A Review of the Critical Strain Energy Density (CSED) Model to Analyzing Reactivity Initiated Accidents (RIA) in High Burnup Fuel

Arthur T. Motta,

April 2004

This is a review of the proposal submission by EPRI to NRC to use strain energy density as a failure criterion for high burnup fuel during an RIA. [1] This review identifies some concerns both in the theoretical basis of the CSED model and in its implementation for the study of RIA. It is concluded that, as presented, the CSED model for analyzing RIA induced fuel failures has basic concerns that need to be addressed and that the model failure predictions may be non-conservative.

Figure 1: Transverse fracture profiles of cladding with a hydride rim tested at (a) room temperature and (b) 300°C, both showing hydride rim induced failure.

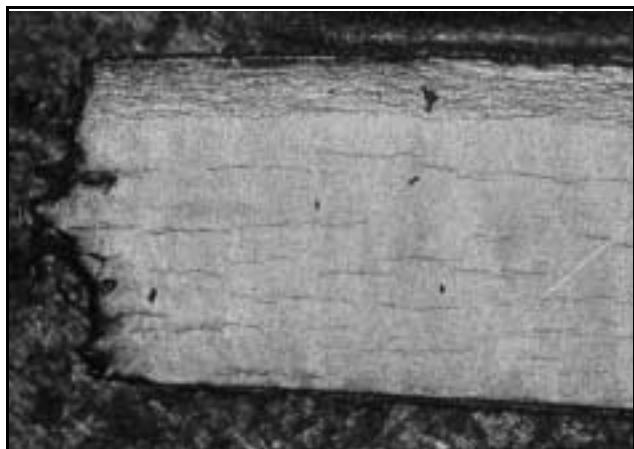
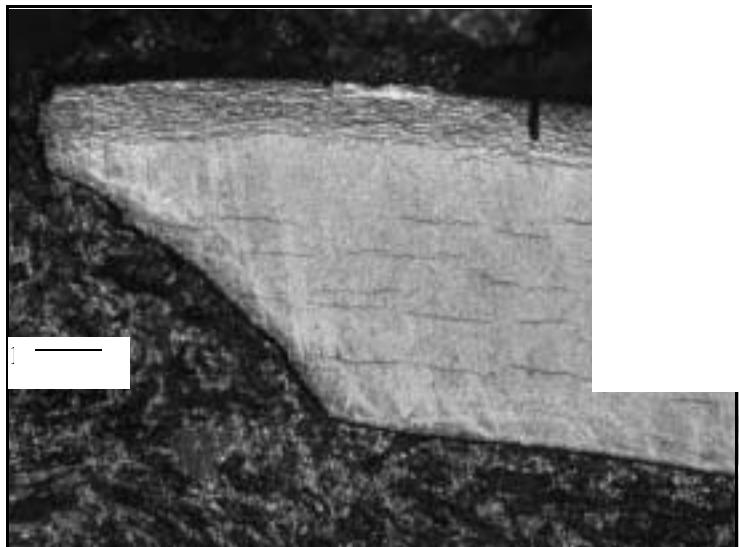
- viii. **Role of hydride rims in degrading cladding ductility.** The authors separate out samples that contain spalled oxide and state that because of blister formation, these samples are more susceptible to failure. The argument is that if spalling can be eliminated from the fuel rods taken to high burnup, blisters will not form and thus the cladding will be less likely to fail. However, the presence of a hydride rim (which does not require oxide spallation) is as penalizing (if not more) than the presence of a blister of equivalent depth [12]. While localization phenomena in general are clearly a possible way whereby cladding ductility can be reduced, [7, 13] it is more likely that a cracked hydride rim causes cladding failure due to crack growth. The criterion for crack growth is sensitive to both crack depth (hydride rim layer thickness) and mode of cracking (e.g., mode I vs. mixed mode I/mode II).

The authors mention that hydride rim limited failures are only seen at room temperature (page 3.13), citing the NSRR tests. [14] It is difficult to verify the occurrence of these phenomena in integral tests because the temperature excursion that follows the reactivity insertion may modify the hydride distribution, but incipient cracks and localization phenomena are seen in various RepNa tests in Cabri where cladding temperatures are ≥ 280 C. In separate effects testing where phenomena can be more clearly identified, it is clear that hydride rim induced failures are also seen at 300 C (albeit with a different failure mode than at room temperature). Figure 1 shows metallography of fracture sections from separate effects testing at room temperature and 300 C. In both cases the hydride rim fails shortly after yielding of the substrate, which causes strain to localize under the cracked hydride rims. At room temperature the crack propagates along a plane normal to the maximum principal stress, while at 300 C, failure occurs by shear at 45 degrees to the principal stress direction. In both room temperature and 300 C tests it is seen that the thickness of the hydride layer is the

critical factor in limiting failure strains. Thus by focusing only on spalled oxide we may be ignoring the degradation problems associated with the presence of hydride rims.
